HISTORIC AND DESIGN REVIEW COMMISSION

May 05, 2021

HDRC CASE NO: 2021-194
ADDRESS: 109 W ELSMERE PLACE
LEGAL DESCRIPTION: NCB 6383 BLK 3 LOT 13, 14 & 15
ZONING: R-5,H
CITY COUNCIL DIST.: 1
DISTRICT: Monte Vista Historic District
APPLICANT: Shea Pumarejo/Younique Designs
OWNER: PHELAN JOHN E & NANCY M
TYPE OF WORK: Fenestration modifications, window replacement
APPLICATION RECEIVED: April 12, 2021
60-DAY REVIEW: Not applicable due to City Council Emergency Orders
CASE MANAGER: Stephanie Phillips

The applicant is requesting a Certificate of Appropriateness for approval to remove three (3) existing one over one windows from the rear addition and install two (2) larger, single lite windows.

A.01

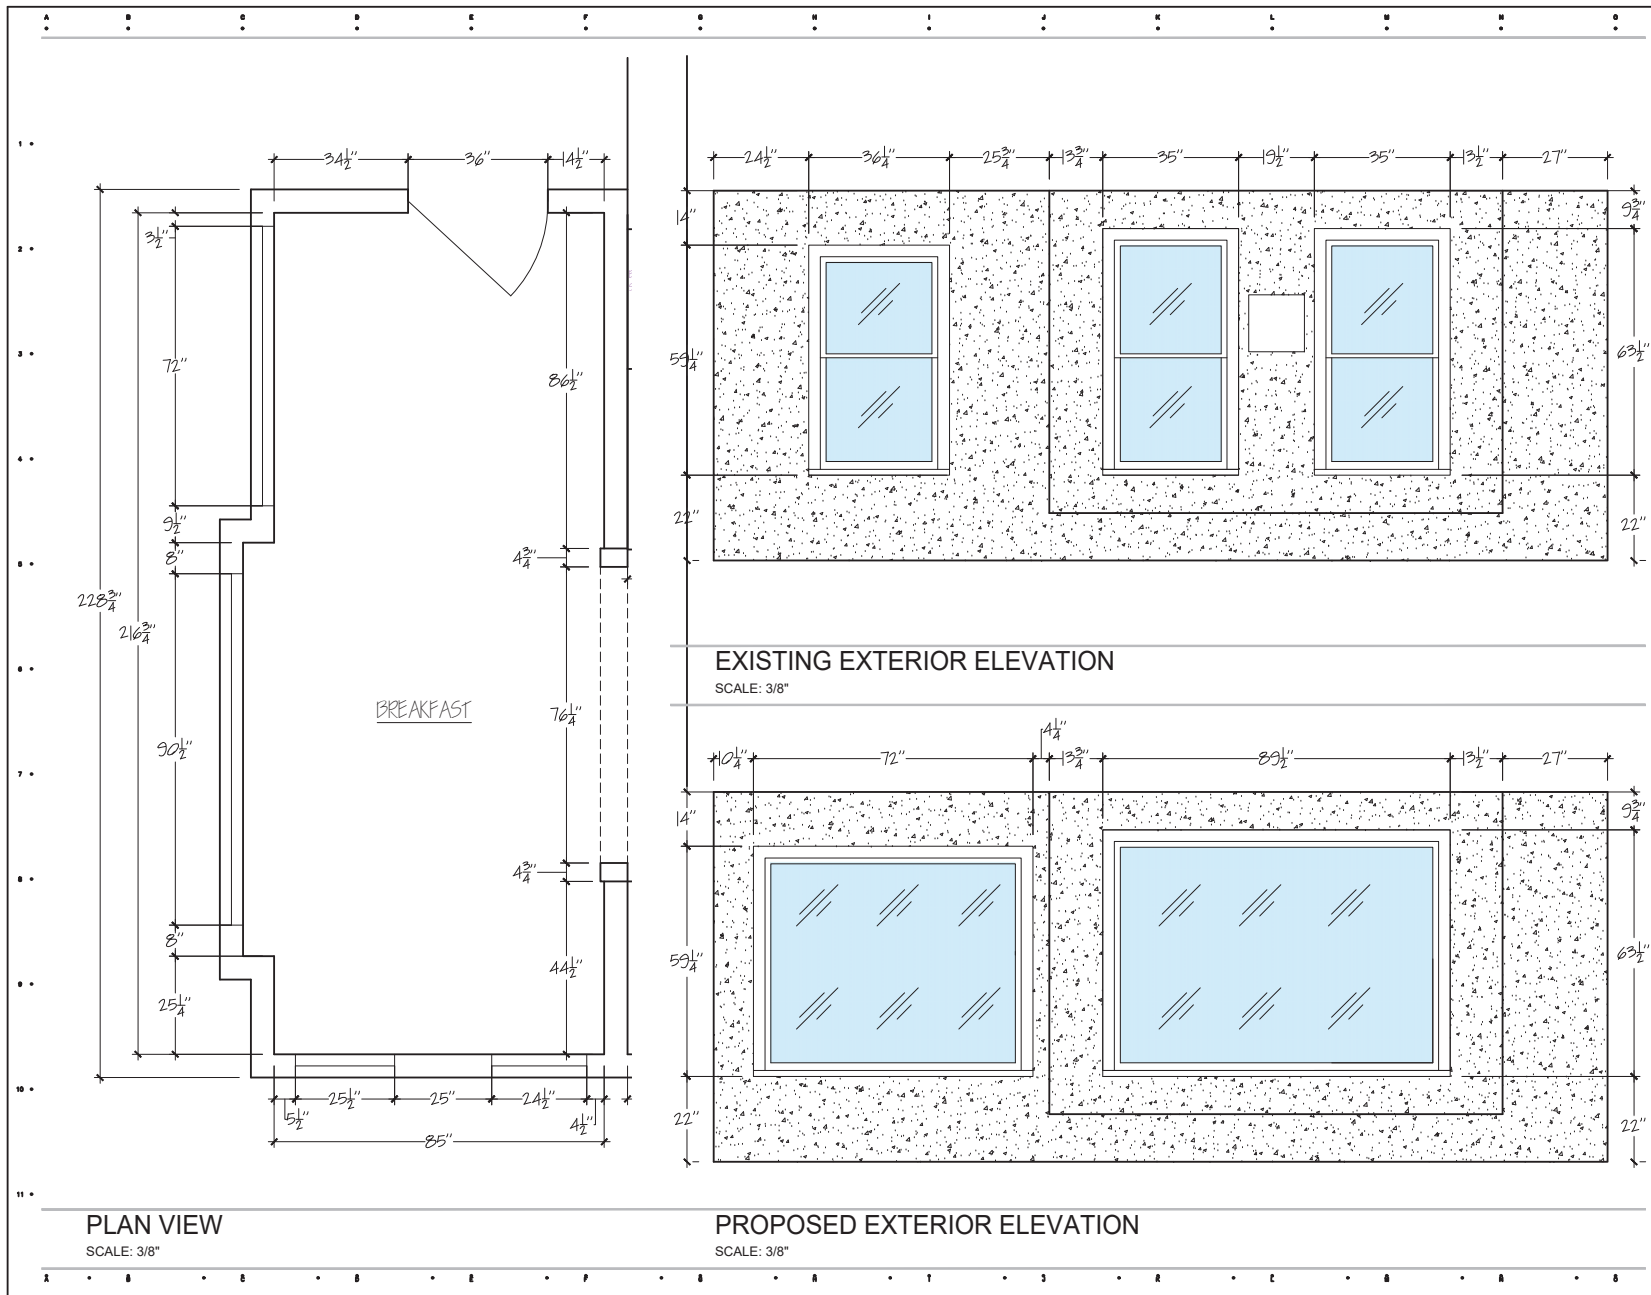
- b. WINDOW REPLACEMENT – The applicant is requesting to replace three existing one over one wood windows on a 1-story rear addition with two large, single lite windows. The elevation faces the rear yard and is not visible from the public right-of-way. The existing windows are not original to the primary structure and are compatible modern replacement products installed sometime prior to 2014. According to the Historic Design Guidelines, additions should be designed to reflect their time while respecting the historic context. Consider character-defining features and details of the original structure in the design of additions. These architectural details include roof form, porches, porticos, cornices, lintels, arches, quoins, chimneys, projecting bays, and the shapes of window and door openings. Windows on additions should relate to the windows of the primary structure in terms of materiality and overall appearance in terms of size, profile, and configuration. While staff finds the windows are not original to the primary structure, staff finds that the proposed windows do not meet the Guidelines in terms of materiality, configuration, profile, and size. Staff finds that the applicant should propose a window configuration that features divided lites, similar to the larger windows on the primary structure and the windows on the rear accessory structure, in lieu of large single panes.

- i. That the applicant proposes windows that feature a divided lite pattern similar to those found on larger windows on the primary structure and the rear accessory structure as noted in finding b. The applicant is required to submit updated elevation drawings to staff for review and approval prior to the issuance of a Certificate of Appropriateness.
- ii. That the applicant submits a final window material specification to staff for the wood or aluminum clad wood windows to staff for review and approval prior to the issuance of a Certificate of Appropriateness.
